**HDS**ARCHITECTURE  
9 & 25 BIRCH STREET & 30 - 36 BAY STATE ROAD

SPECIAL PERMIT APPLICATION APPENDICES | JUNE 05, 2026

## MEMORANDUM

**Subject:** 25 Birch Street Transportation Impact Study (TIS)

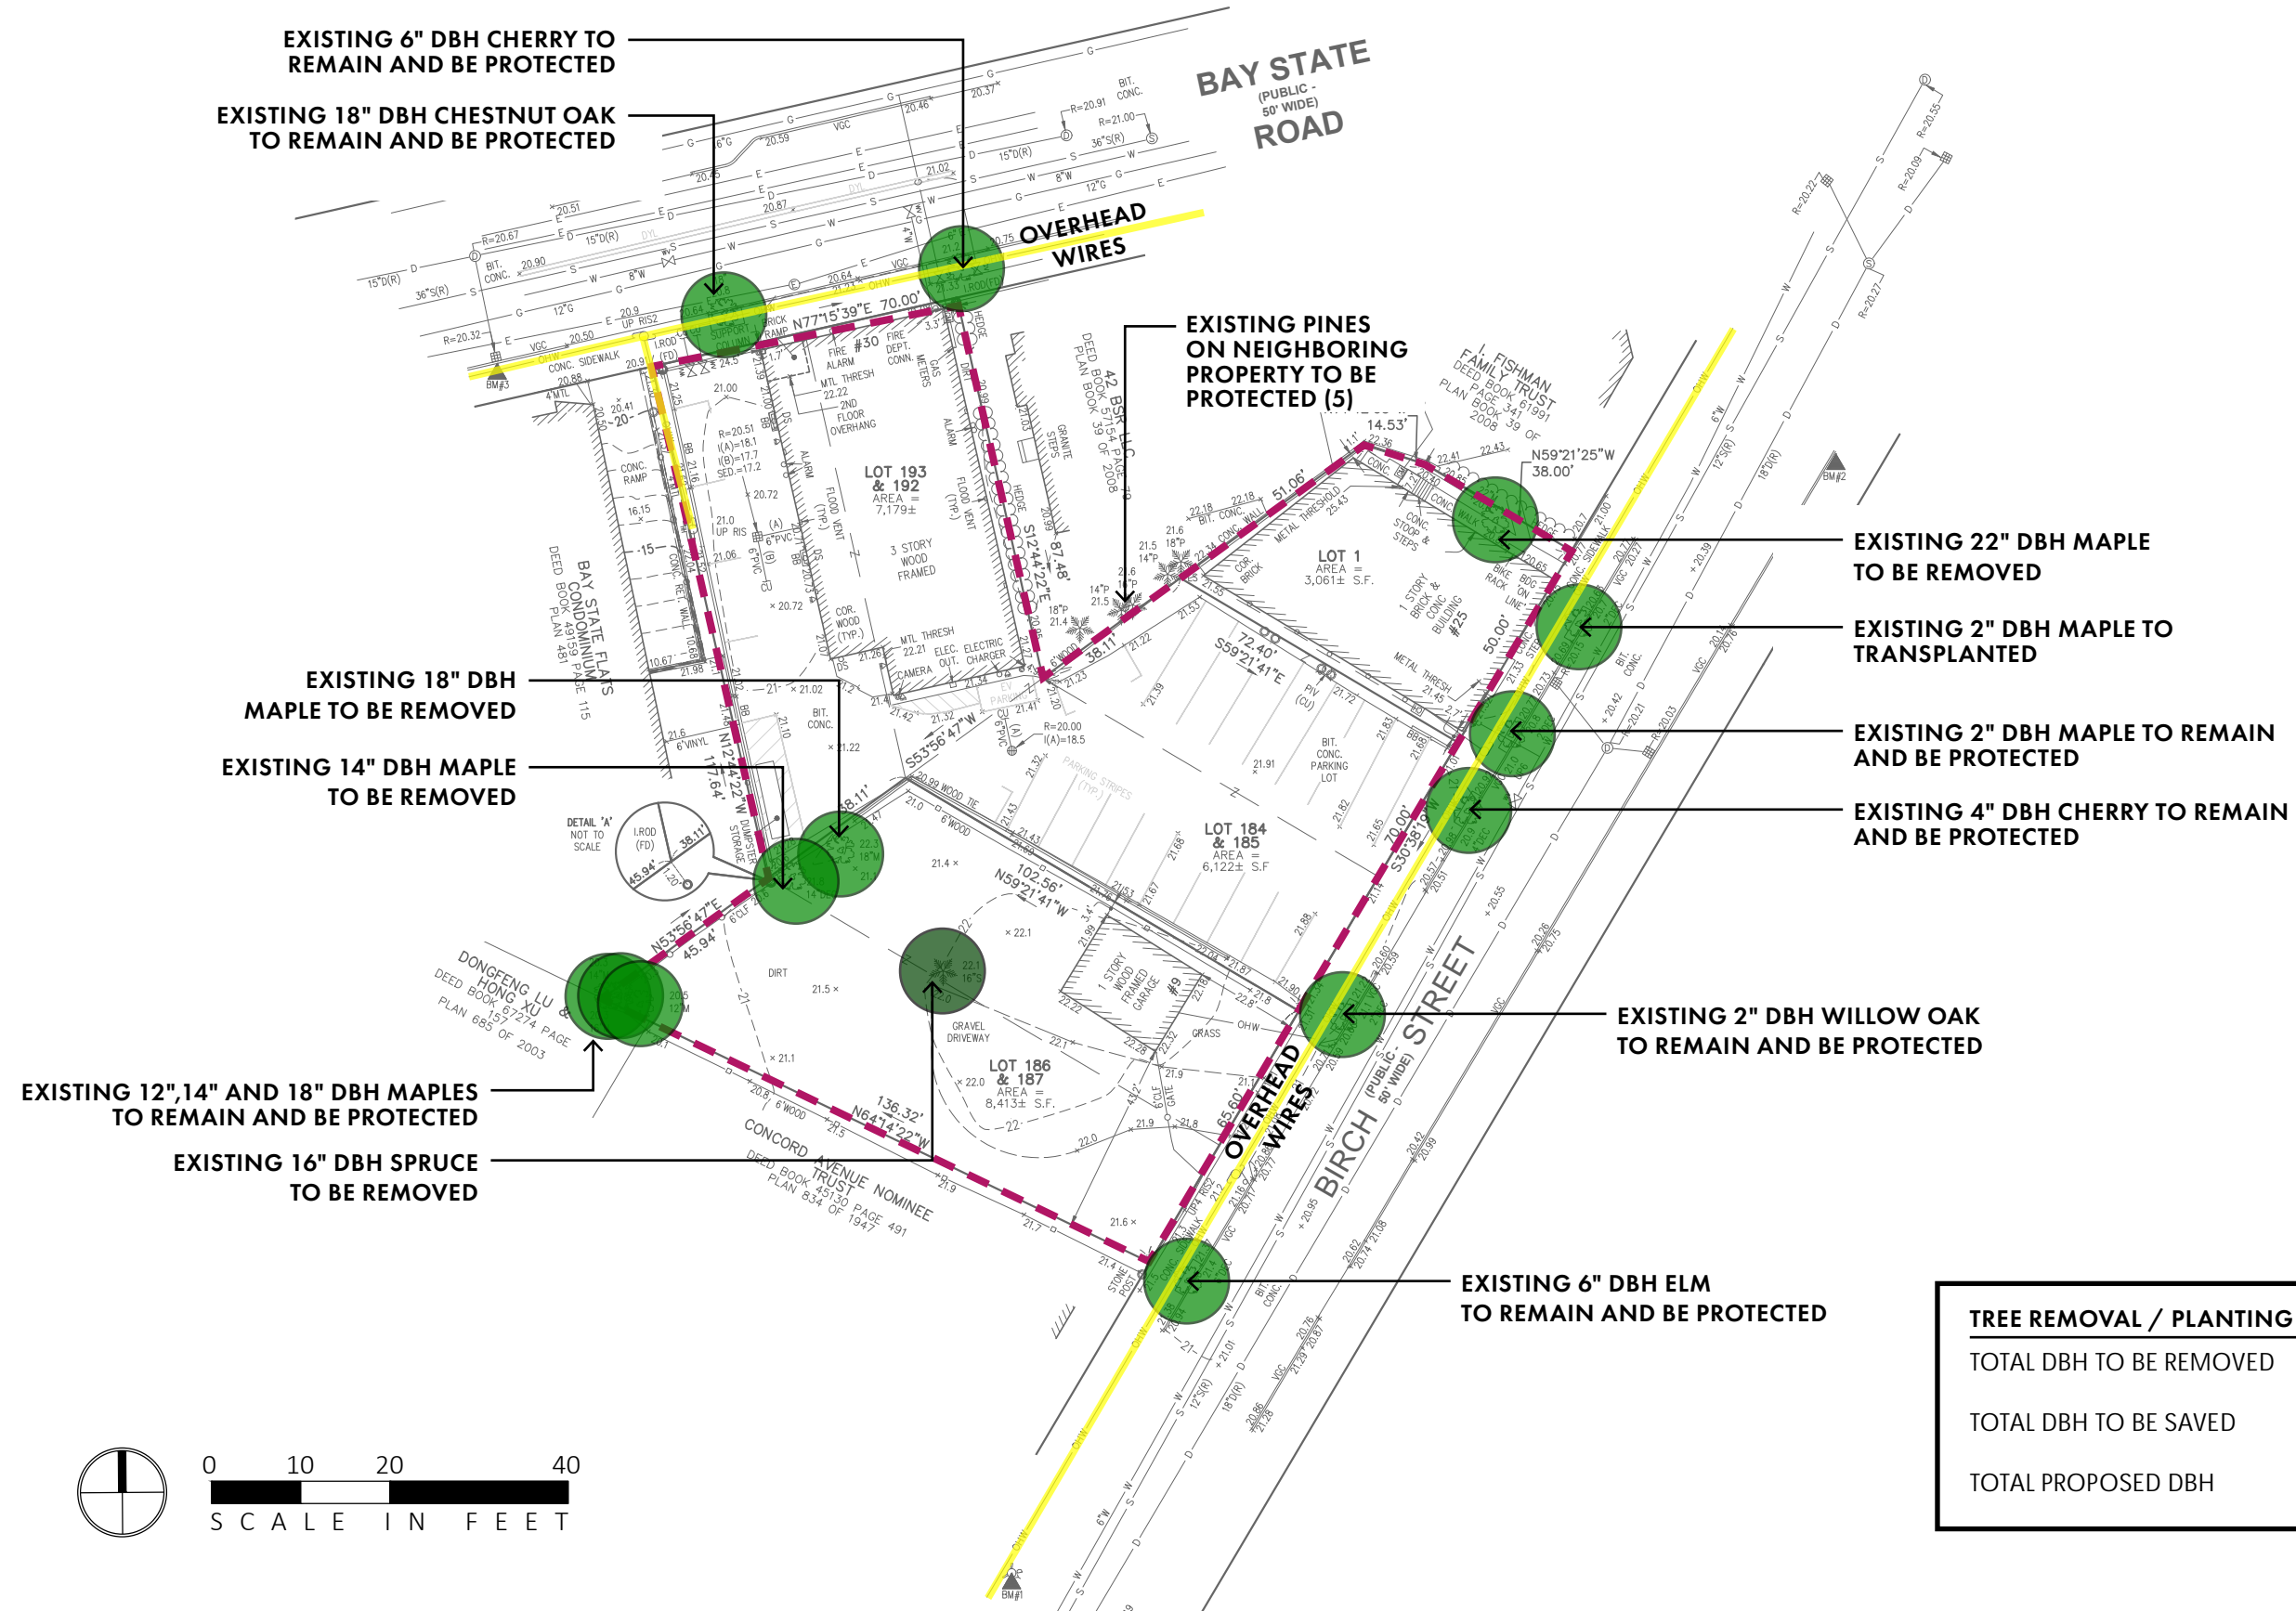
After reviewing the updated TIS, we certify that the study is accurate and complete, pending the corrections listed below. Please resubmit the TIS with the following revisions:

- Update Figure C.1 to reflect the latest site plan.
- Revise the bike rack layout shown in Figure 9.c.5. It currently depicts a 24-inch clearance from a wall, while City guidelines require a minimum of 36 inches.
- Clarify or expand upon the comment on page 39 regarding the volume-to-capacity ratio calculation for the Red Line and why it may not reflect rider experience.
